LETTER OF SUBMITTAL
KFM Skyway Project # 04-012024

Subject: USI - Documents Clearing USI W M NCR #65 (METS#51)

Reference: SFOBB Skyway Project
USI #23932 (NCR LTR# 65.121604)

Subject: KFM/USI NCR No. 51: Deviating from Approved Fabrication Procedures (Fabrication of soffit plates pal 9 and pa20)

Wing Plate Pa23

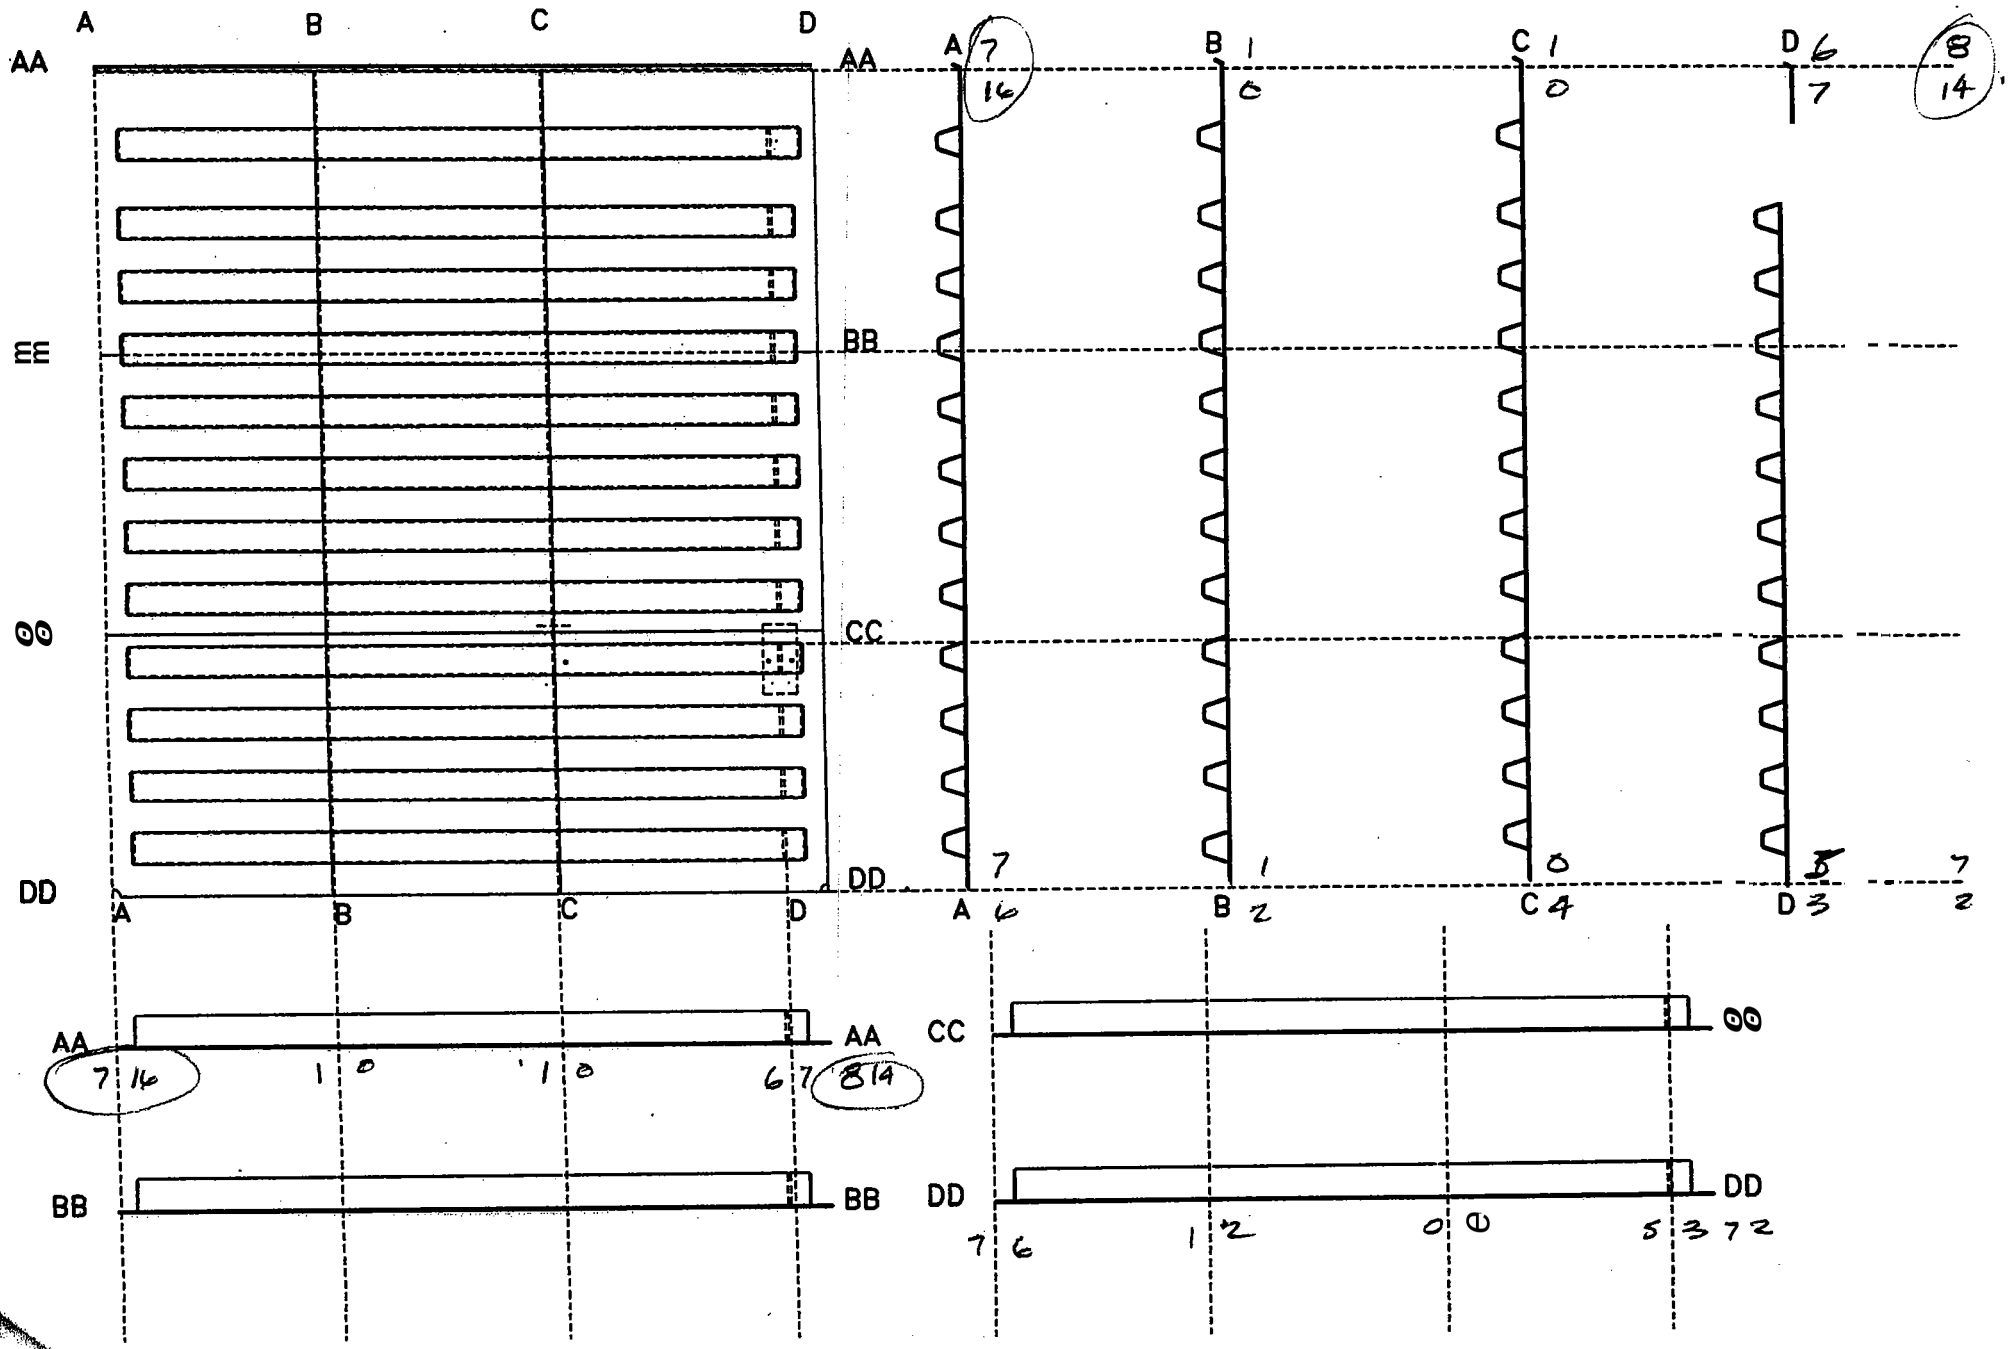
Step 1 - Details of Incident:
Dimensions pulled with a Lazer Level on Nov 4 (See attached Dwg)

THE OUTSIDE MEASUREMENTS ON AA-AA INDICATE 9mm & 7mm TOO HIGH THESE ENDS AT UNWELDED TO JOIN ADJACENT GIRDERS. THIS WILL FIT OUT WITHOUT ANY PROBLEM DECK PLATE FITTING WILL ALSO ASSURE PROPER LINE-UP.

CHANGE WELDING TO GO FROM BOTTOM-UP INSTEAD OF TOP TO BOTTOM.

Wing Plate Pa27

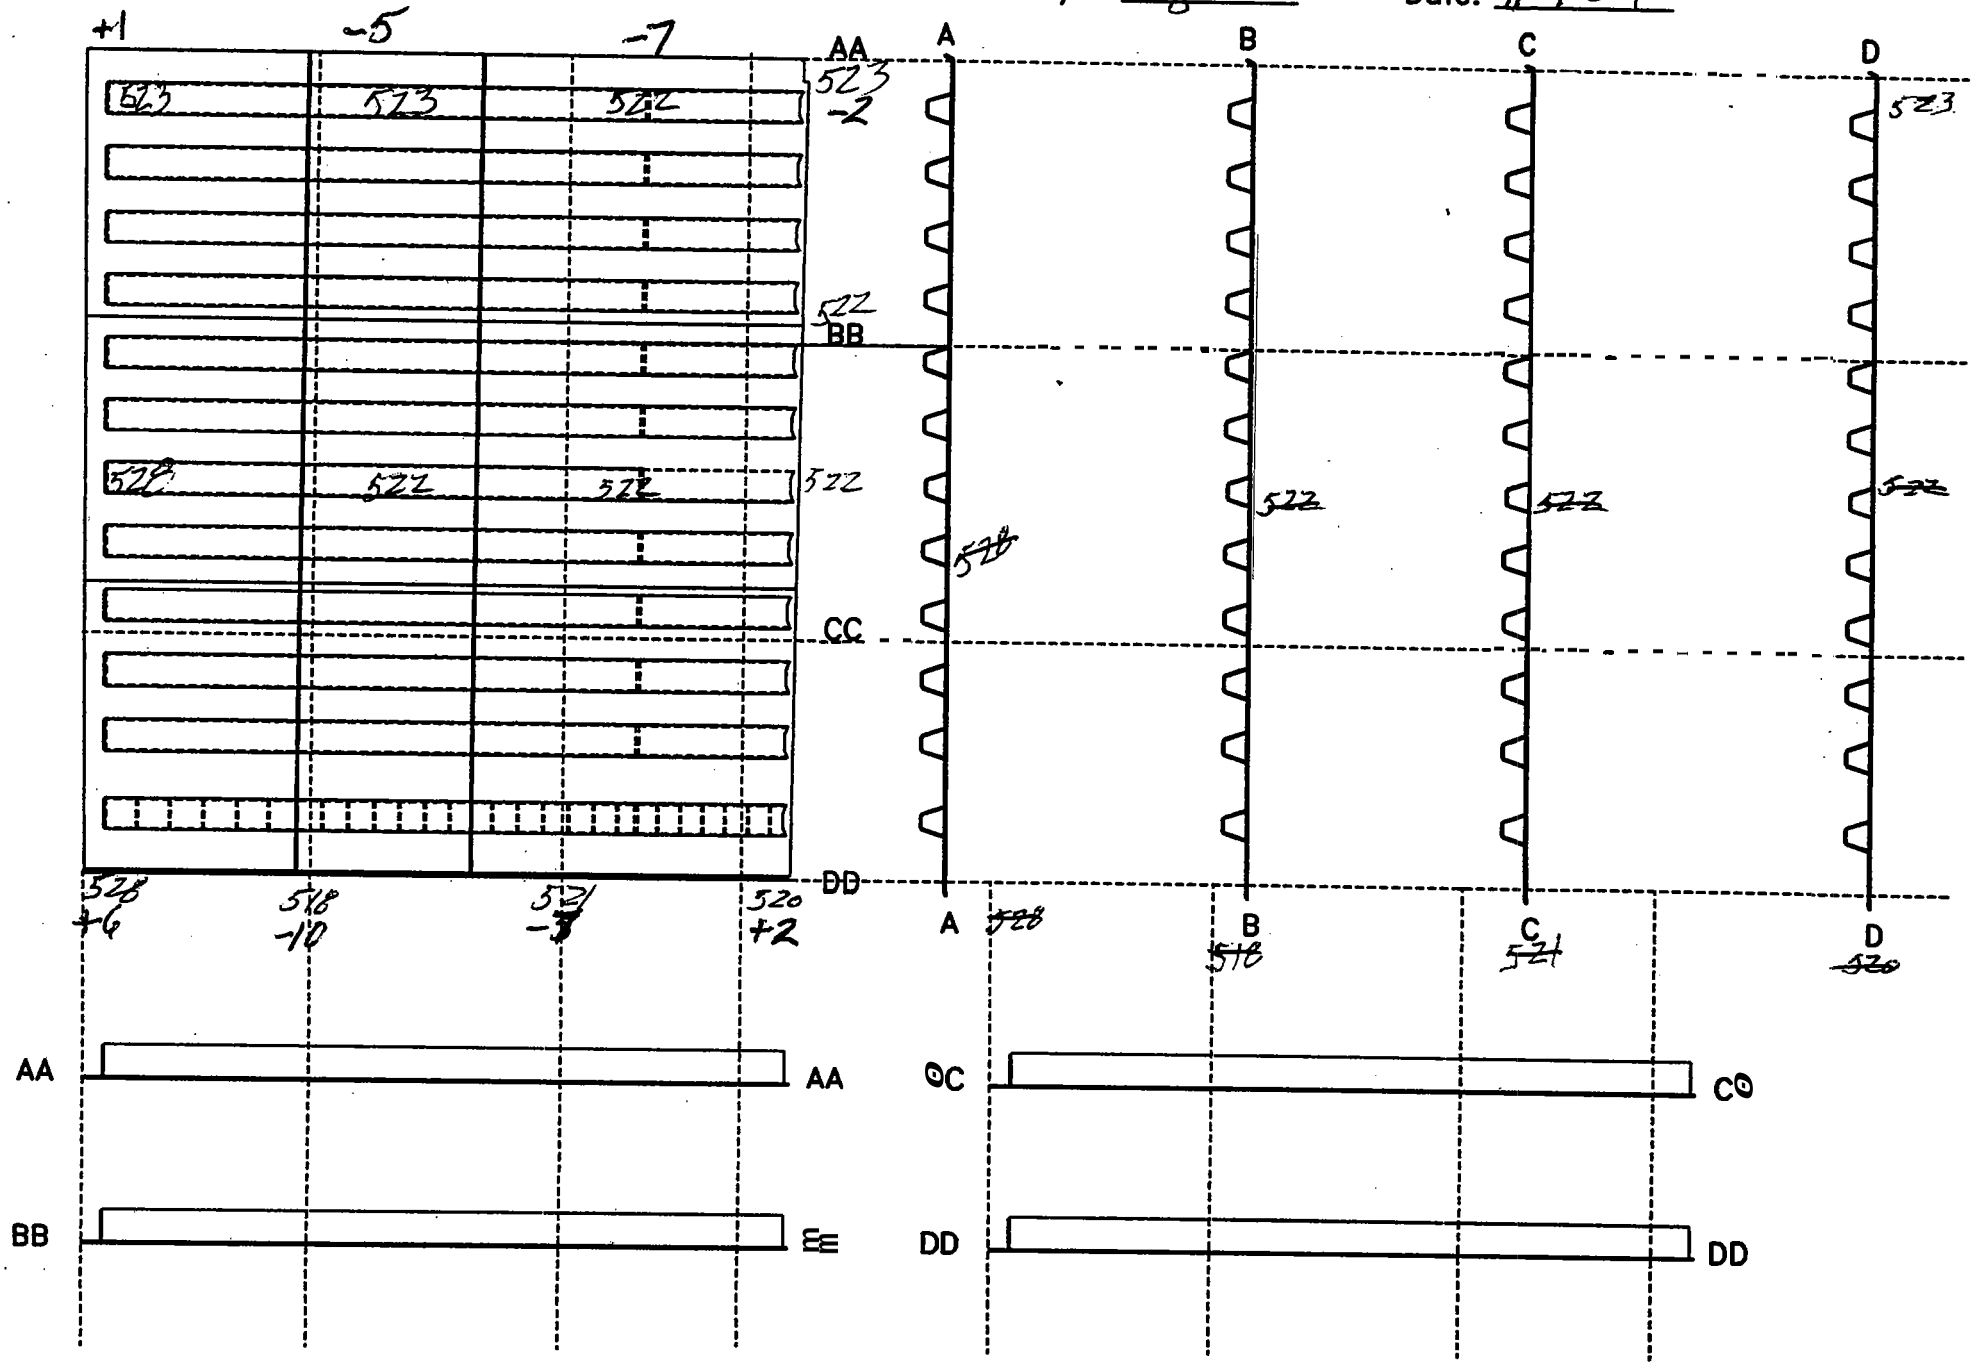
Pa27 wing PL has been shot in with the Lazer Level. Elevations vary from elevations given on Drwg 27A/C rev3. See attached sheet

wall distortion due to welding ribs — Pa 27

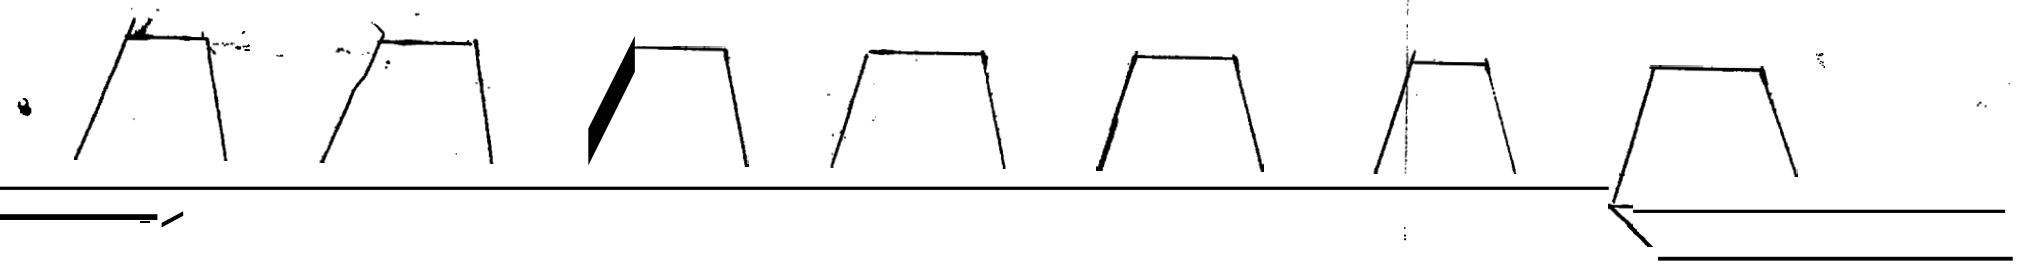
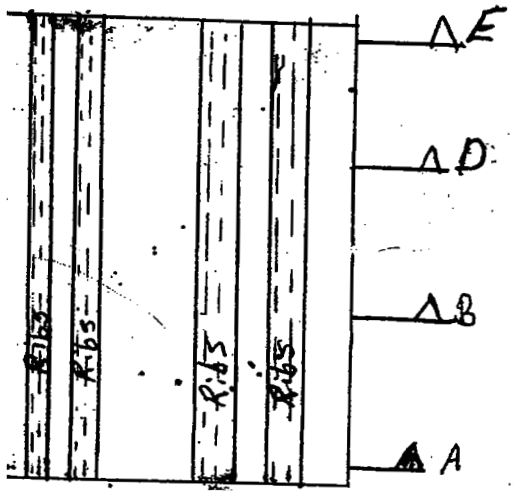
Welding the ribs to the Pa27 caused distortion at the outside rib (see attached sketch)

~~Apply heat as recommended in heat straightening repair procedure~~
THE PLANT MANAGER HAS REVIEWED THIS DISTORTION AND HAS FOUND THAT IT WILL BE WITHIN TOLERANCE AFTER FITING DIAPHRAMS, T-STIFFENERS AND GUSSETS HAS BEEN PERFORMED

Pa 49

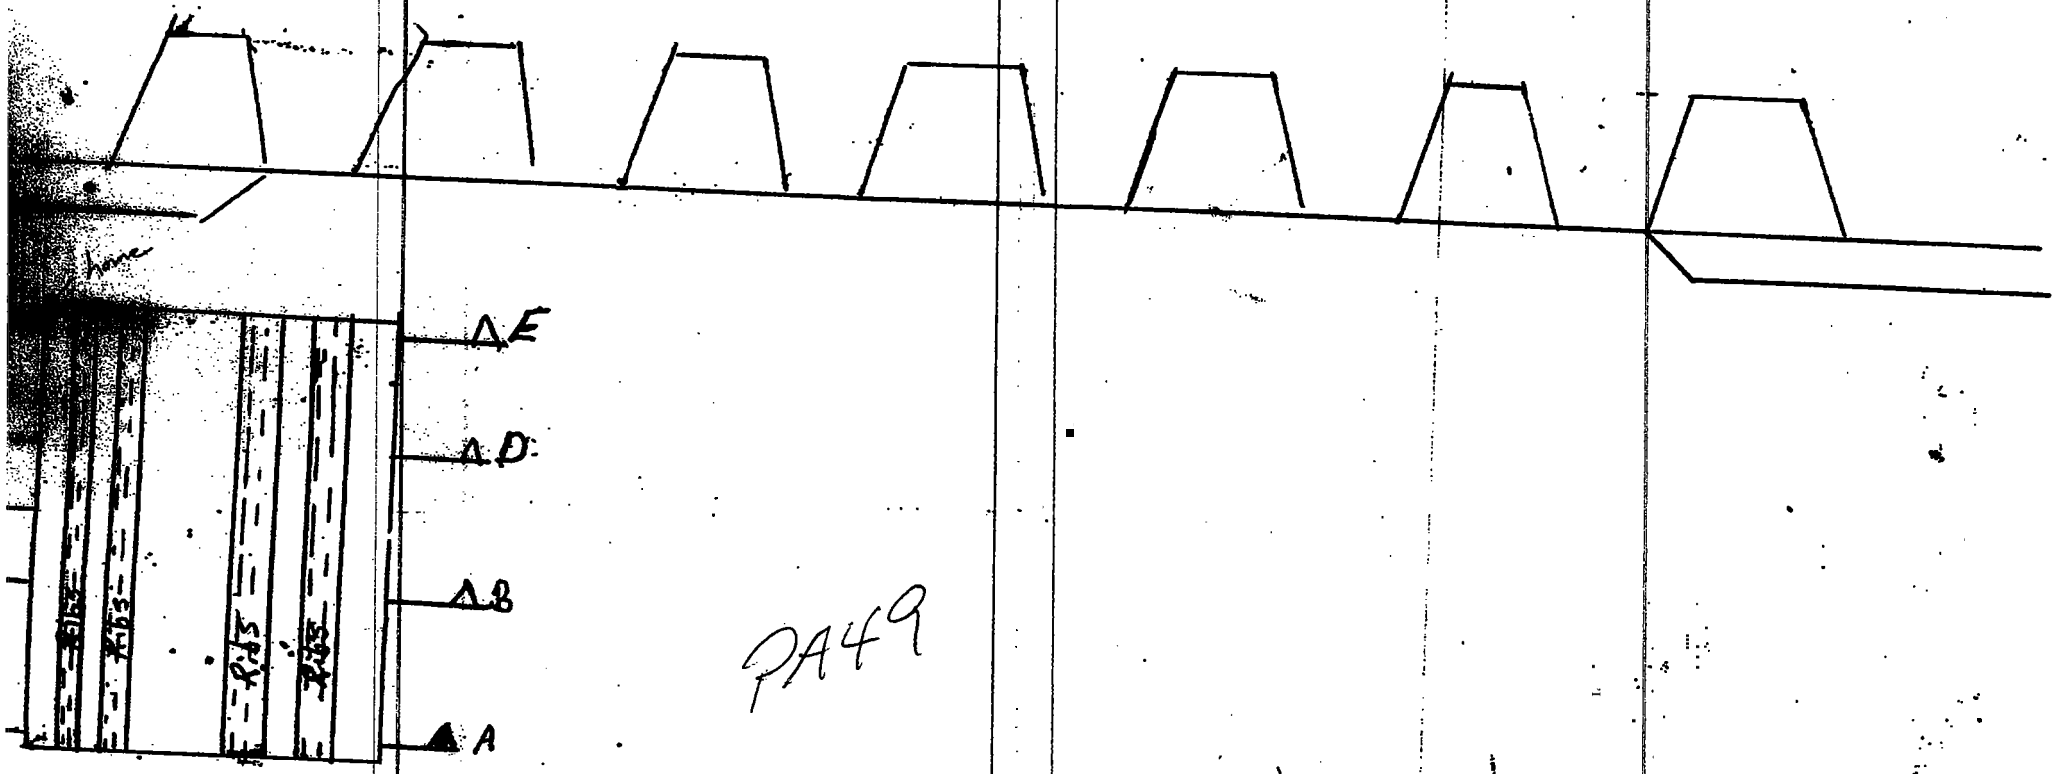
web Pa 49 has weld distortion. (see attached sketch)

Weld distortion due to welding rib

THE PLANT MANAGER HAS REVIEWED THIS PROBLEM AND FINDS THAT THE DISTORTION WILL NO LONGER BE OUT OF TOLERANCE WHEN THE WEB IS AT TO THE SOFFIT.

PA 50 GIRDER 3A

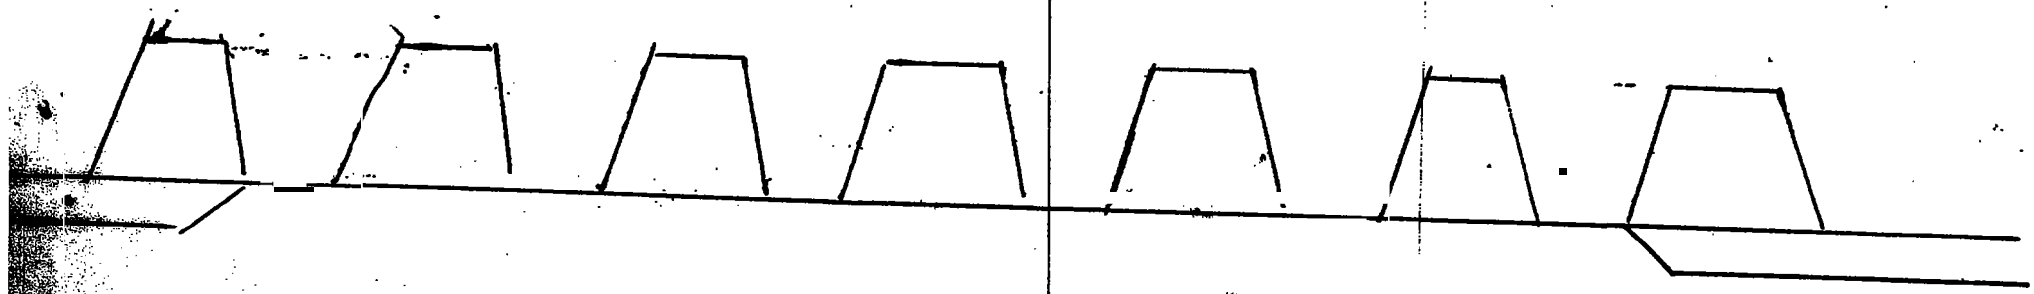
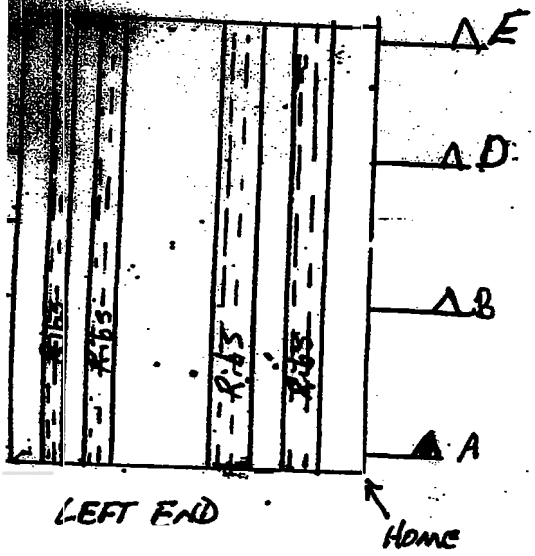
WEB PLATE ASSEMBLY 23950 on GIRDER 34 HAS WELD DISTORTION - SEE ATTACHED SKETCH

PLANT MANAGER HAS REVIEWED THIS PROBLEM AND CONCLUDES THAT THE DISTORTION WILL NOT BE OUT OF TOLERANCE WHEN THE WEB IS FIT TO THE SOFFIT.
